Product/Process Change Notice (PCN)

PCN #: WR-WTB 1.5mm

Product Affected: 648x0113722(DEC)

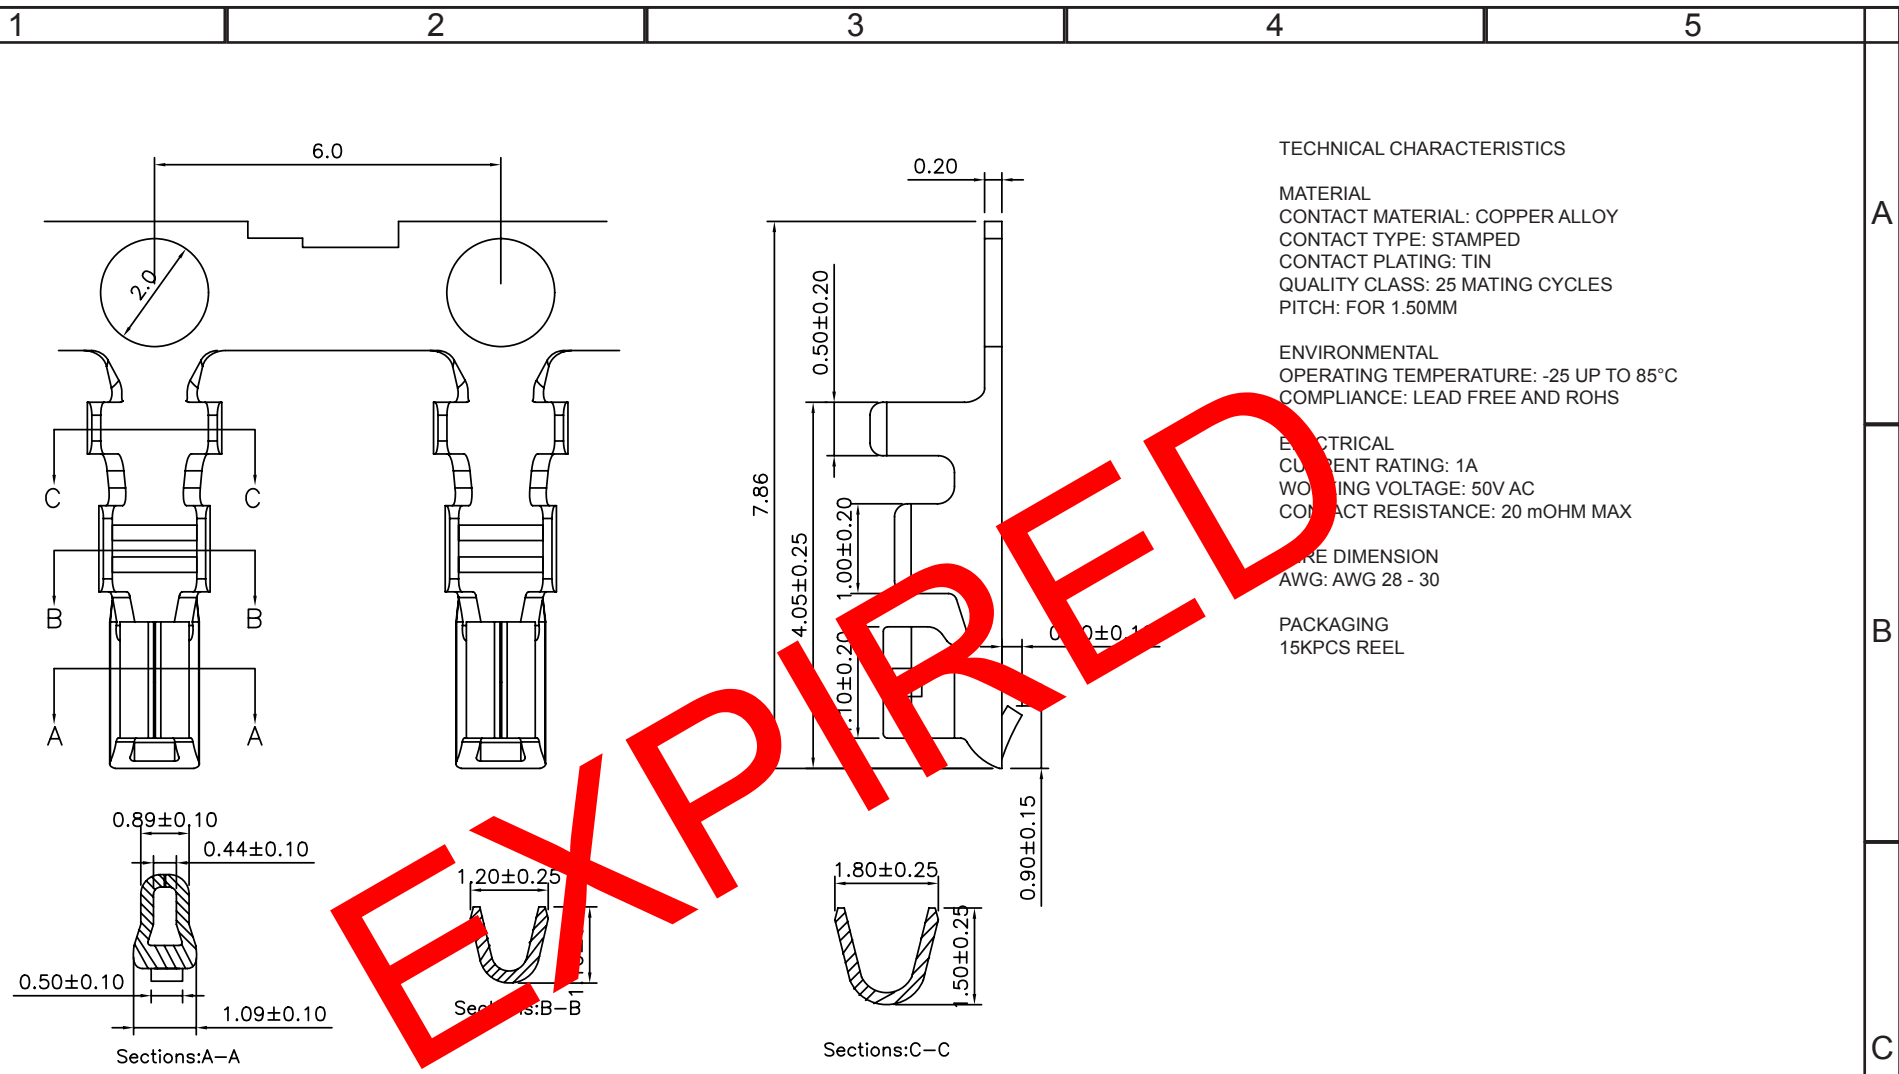
The tooling has been improved to increasing the crimping efficiency.

See below datasheets.
